Re: Response to Comments Proposed Mine Plan Amendment. Sentinel East Backfilling. Lisbon Valley Mining Company LLC. 920 South County Road 313, La Sal, Utah, 84530.

Re: Response to Comments Proposed Mine Plan Amendment. Sentinel East Backfilling. Lisbon Valley Mining Company LLC. 920 South County Road 313, La Sal, Utah, 84530. BLM Ref. 3809 (UTY02) UTU-72499

Response to BLM Reason #1 and Remand, Sentinel East Backfilling

Figure 2. Structural Contour Surface of the Top of the Morrison Formation, Showing Extent of Saturated Burro Canyon Formation (6,180 ft Static Water Level)

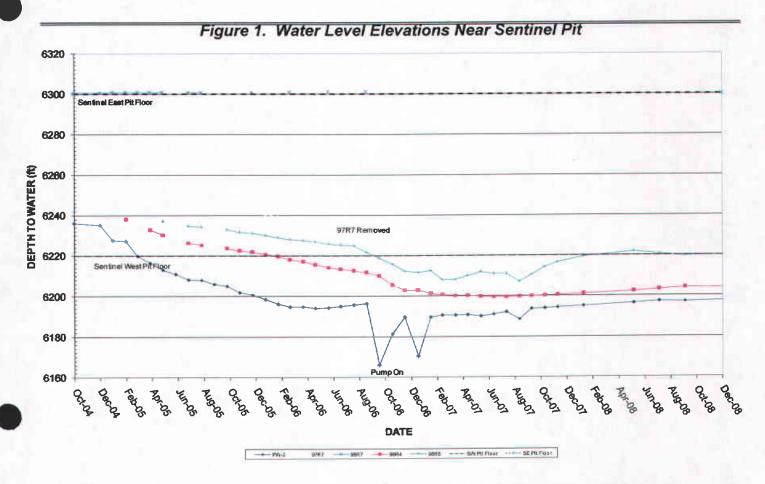
If water levels were to rise, for some yet unknown reason, it is not clear that the aquifer would expand horizontally below the Sentinel East Pit rather than spill over from the concave surface of the Morrison Formation (Figure 2) or flow horizontally downvalley (southeast). A significant quantity of water would be required to raise the water levels in the Burro Canyon Aquifer to the spill point, or to the floor of the Sentinel East Pit.

Note saturated BC aquifer in blue, and potential spill-over point down-valley (SE) out of the page.
